UNITED NUCLEAR CORPORATION
COMMERCIAL PRODUCTS DIVISION / ROUTE 21A, HEMATITE, MISSOURI 63047

Subject: Renewal of Special Nuclear Materials License SNM-777, Docket 70-820 Regulatory File Cy.

RESPONSE TO AEC COMMENTS ON RENEWAL OF SPECIAL NUCLEAR MATERIAL LICENSE SNM-777, DOCKET 70-820

Figure 309-XXIV

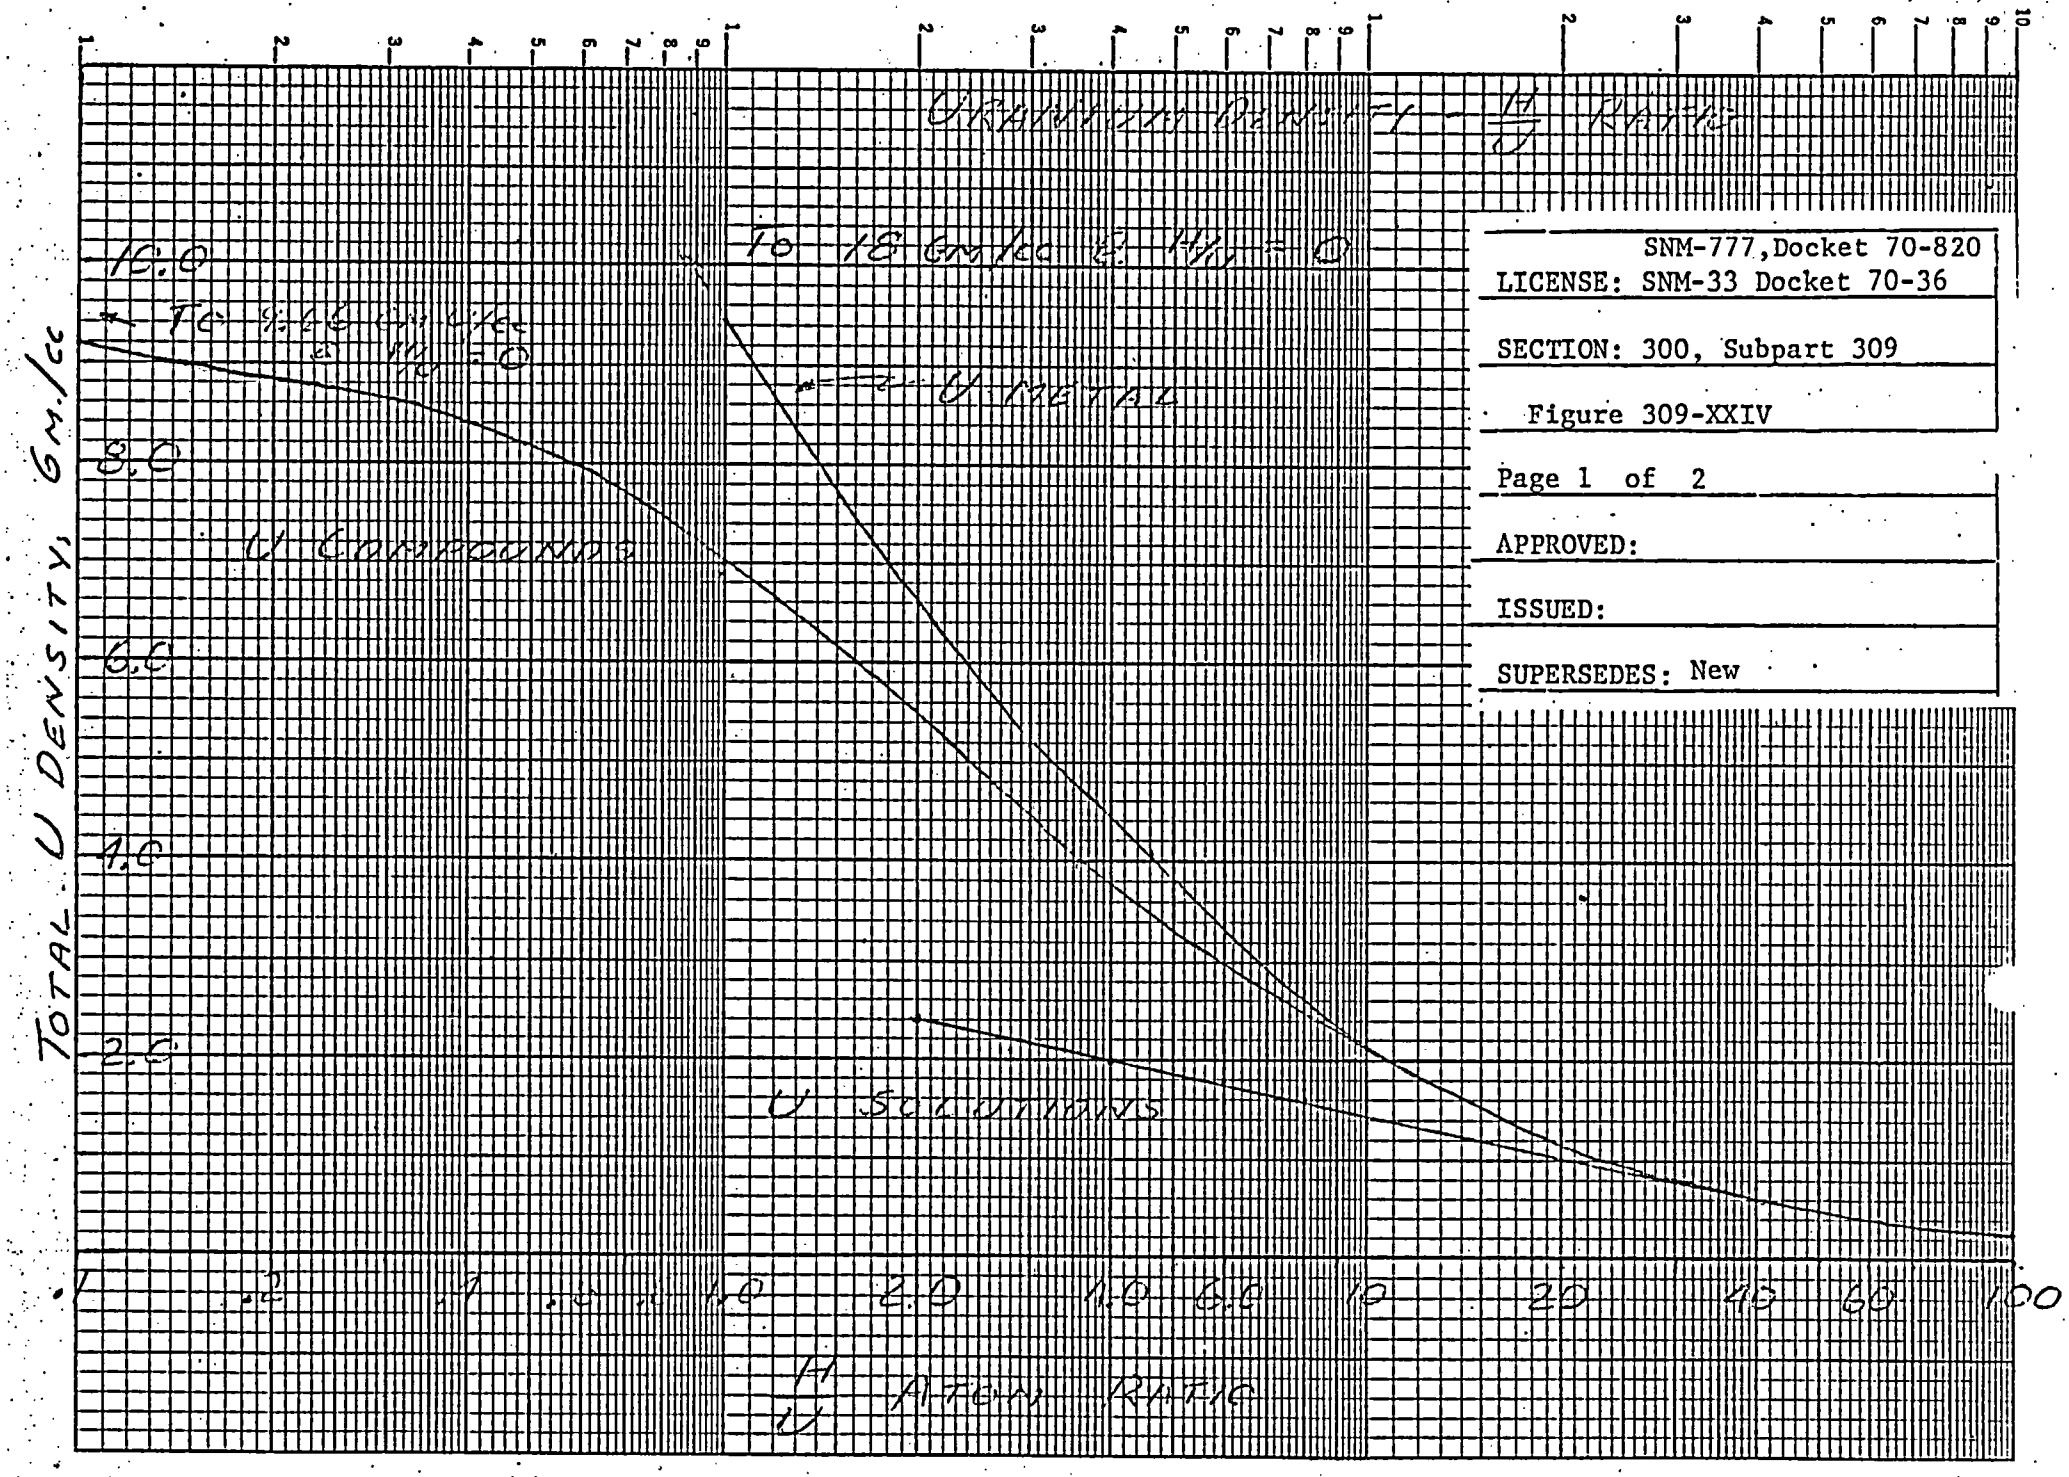
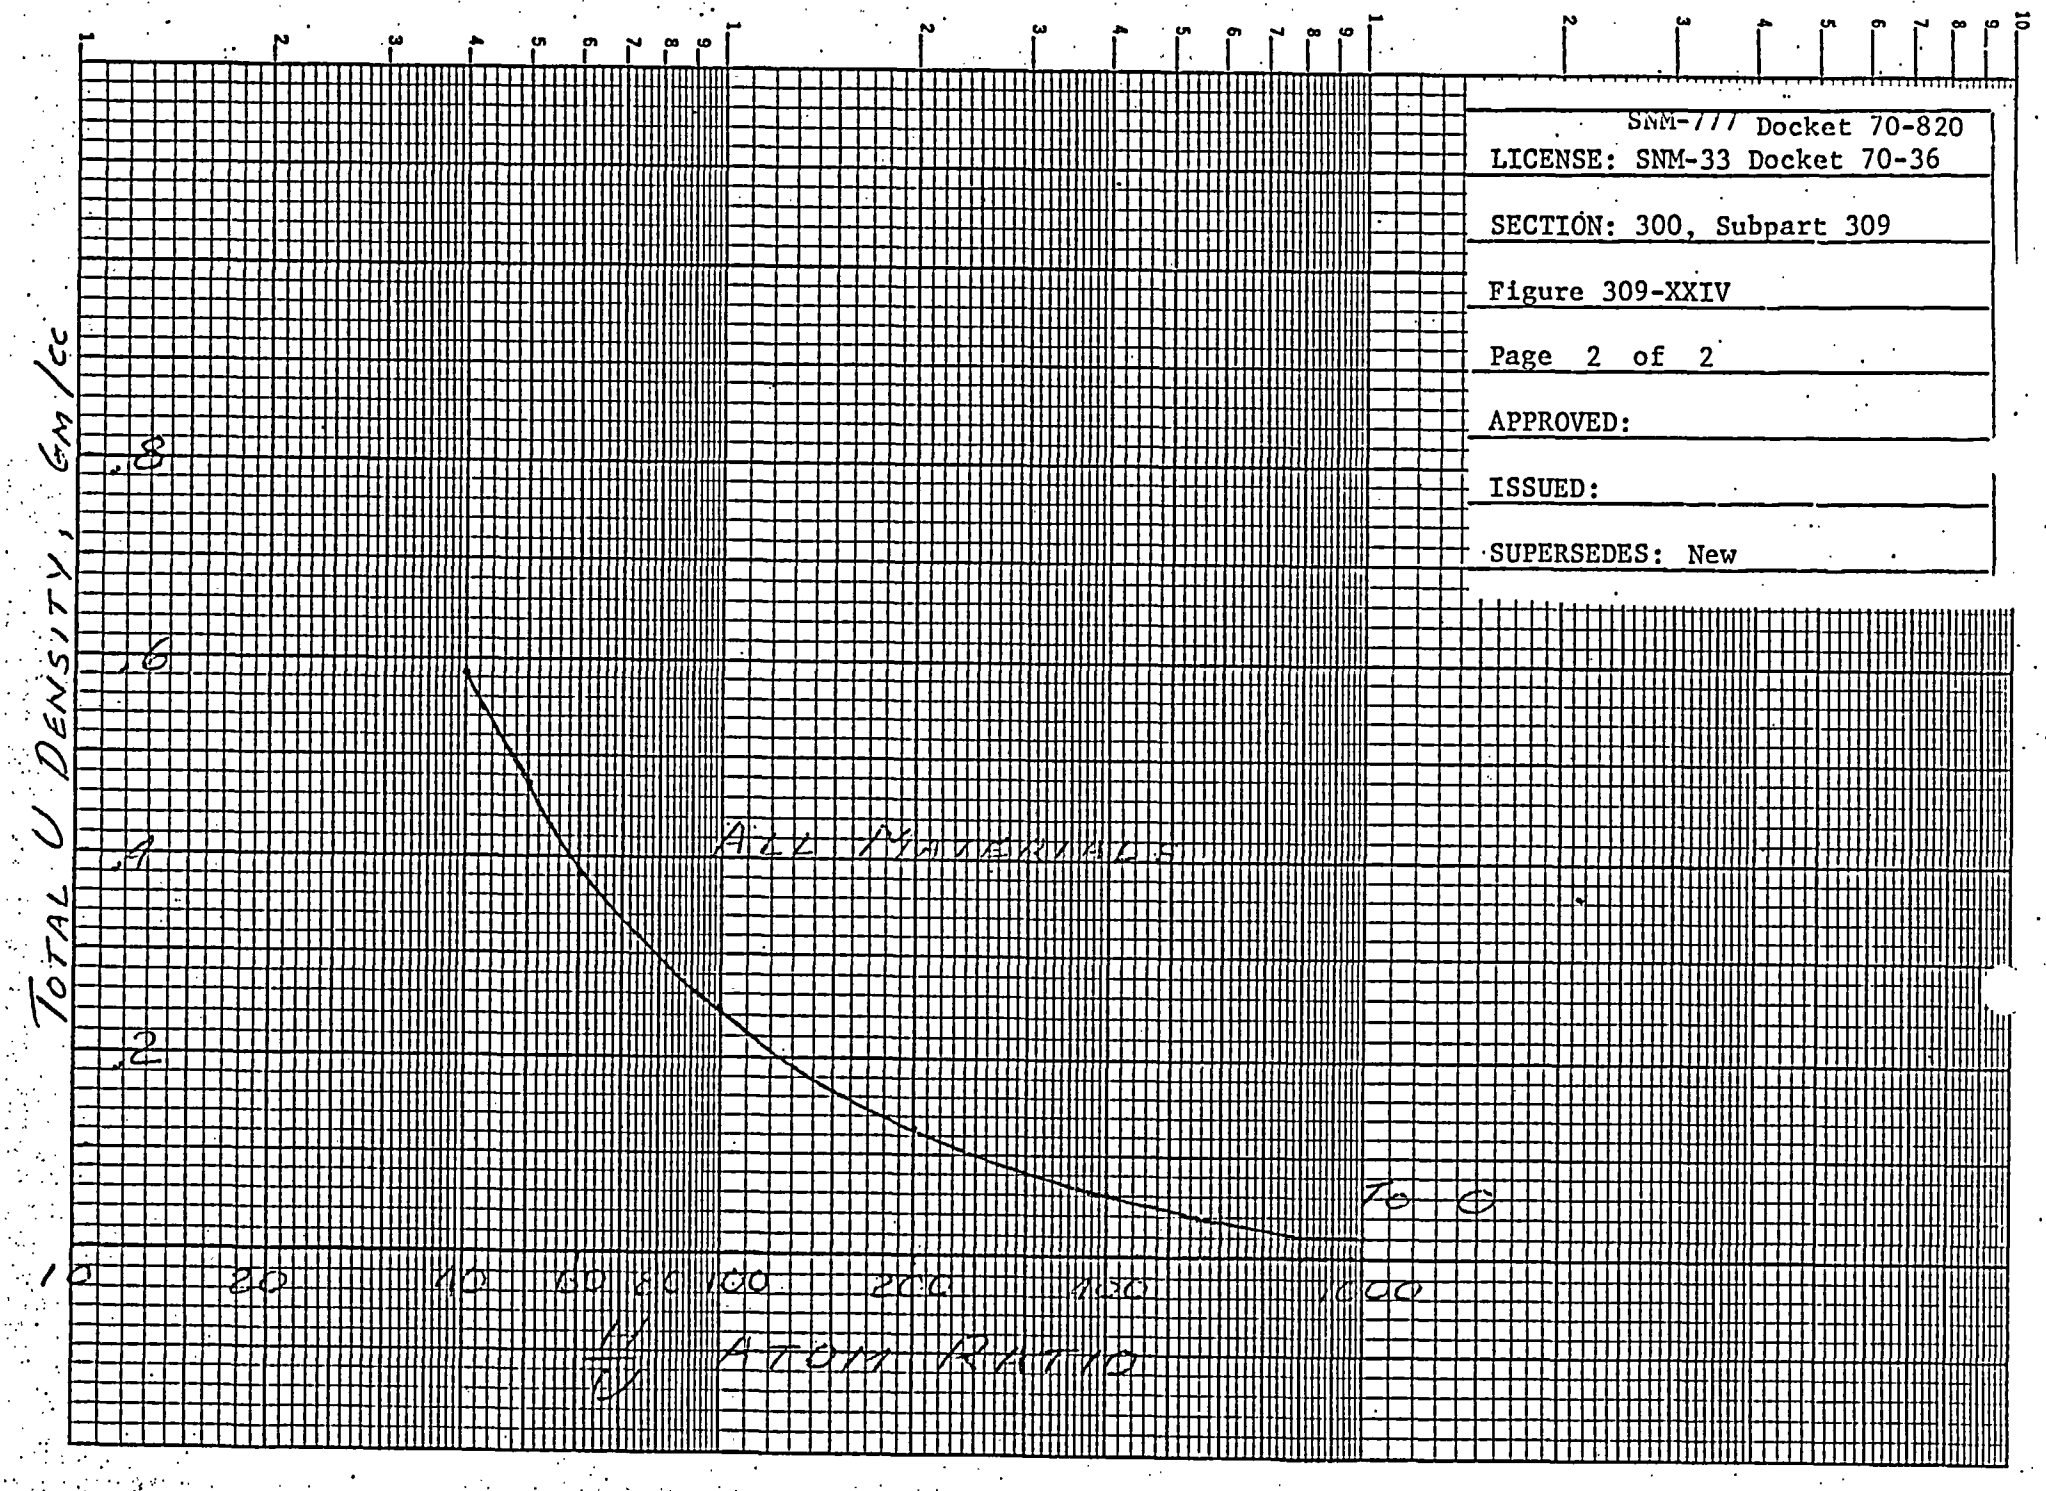
Comment: How is the actual material density known?

Answer: Uranium solutions processed within the scope of this license have uranium concentrations no greater than that of UO_2F_2.

Uranium compounds processed within the scope of this license have bulk densities not greater than that of UO_2 powder which has a bulk density not more than 4 grams U/cc. Refer to Figure 309-XXIV.

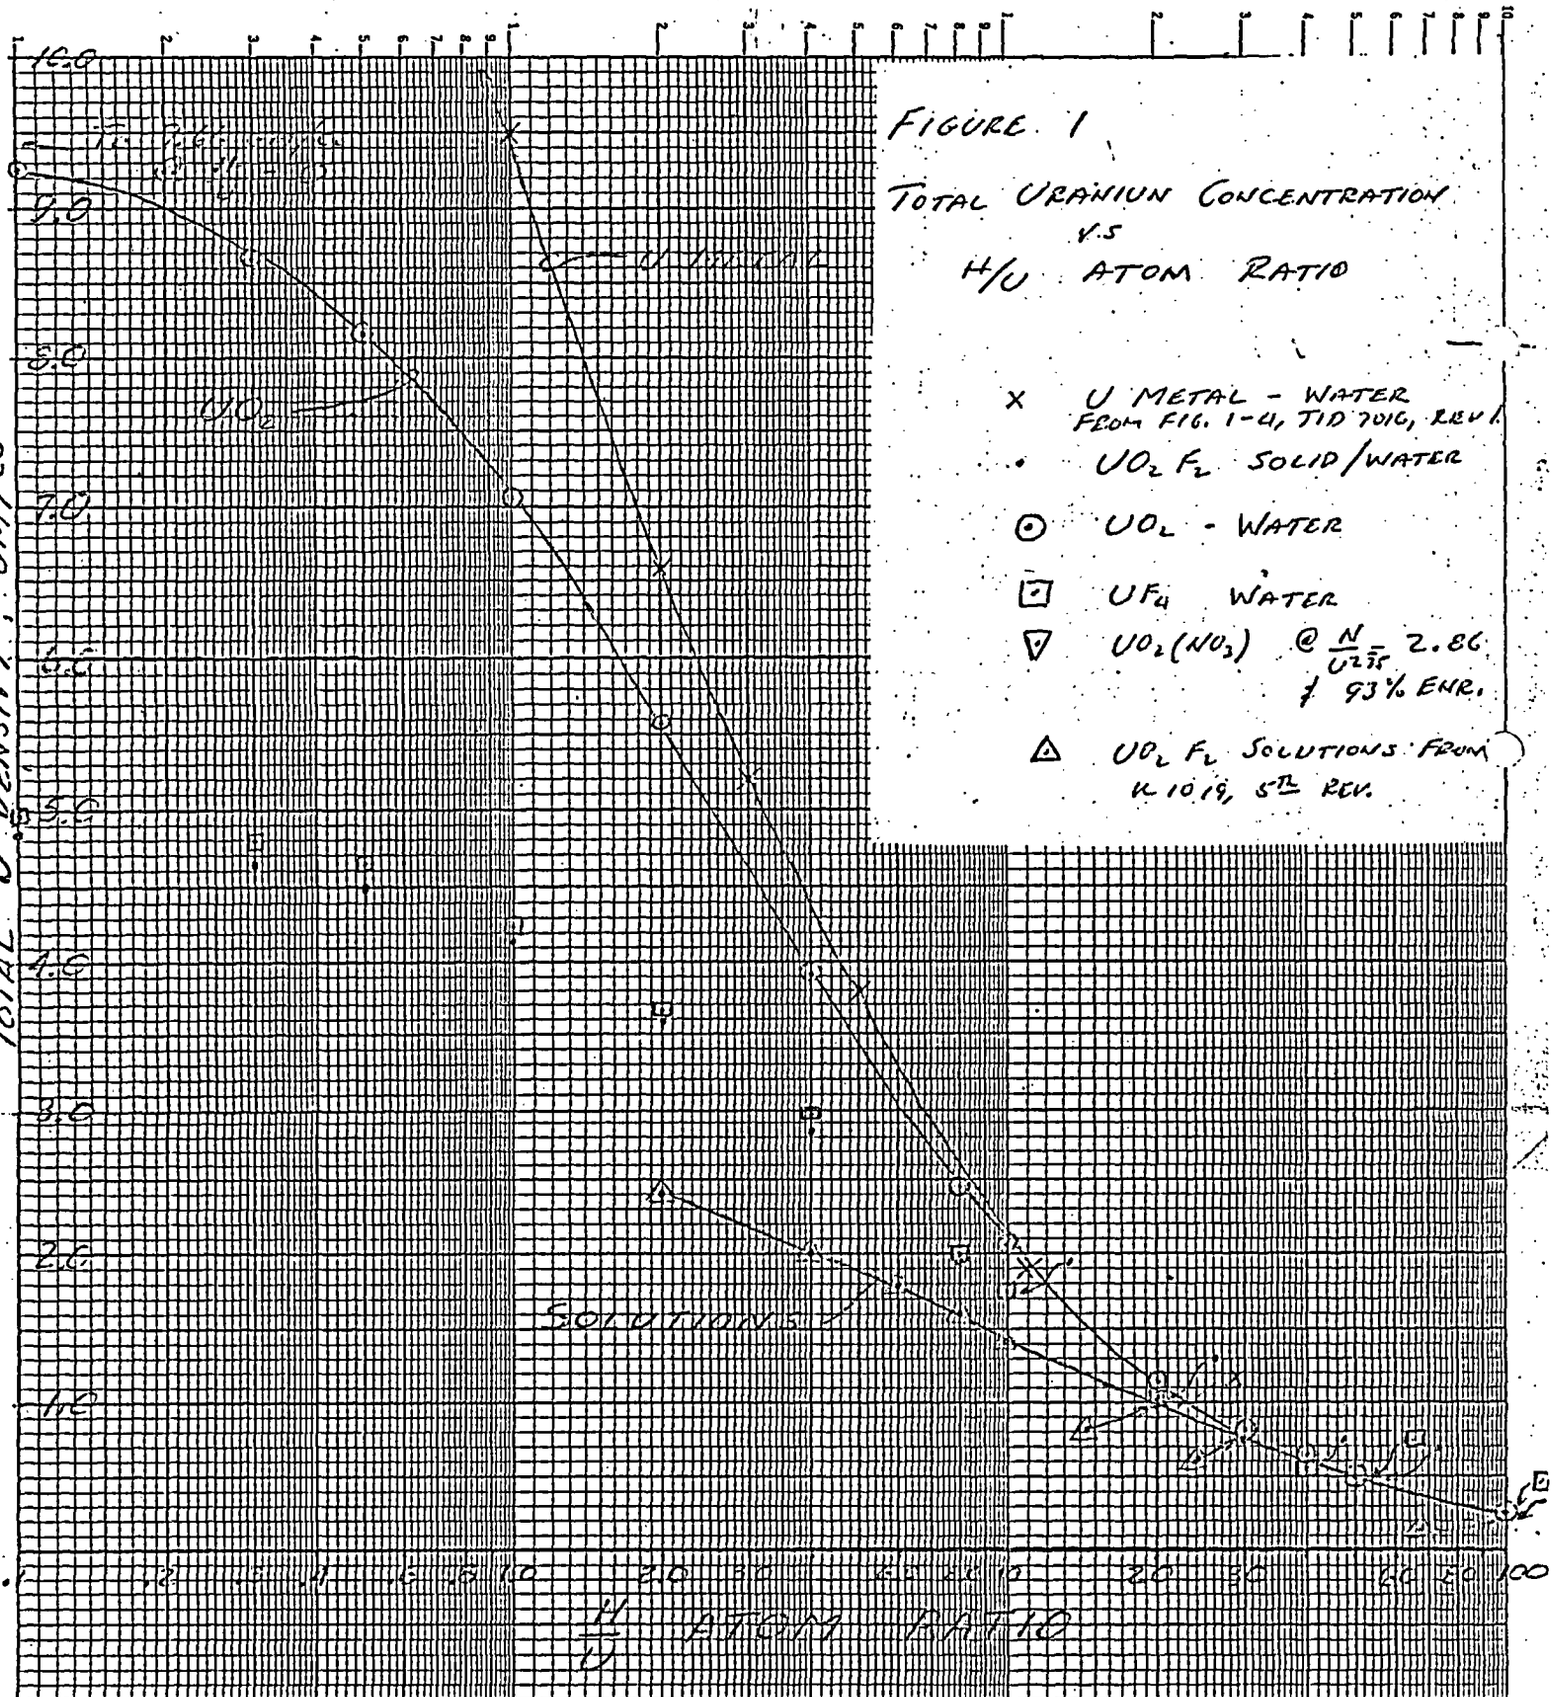
These are included to reflect AEC comment on density/moderator relationship.

Replace Tables 309-I and 309-II with attached revised tables and associated Nuclear Safety Evaluations. Add Figures 309-XXIV through 309-XXVIII and their associated Nuclear Safety Evaluations.
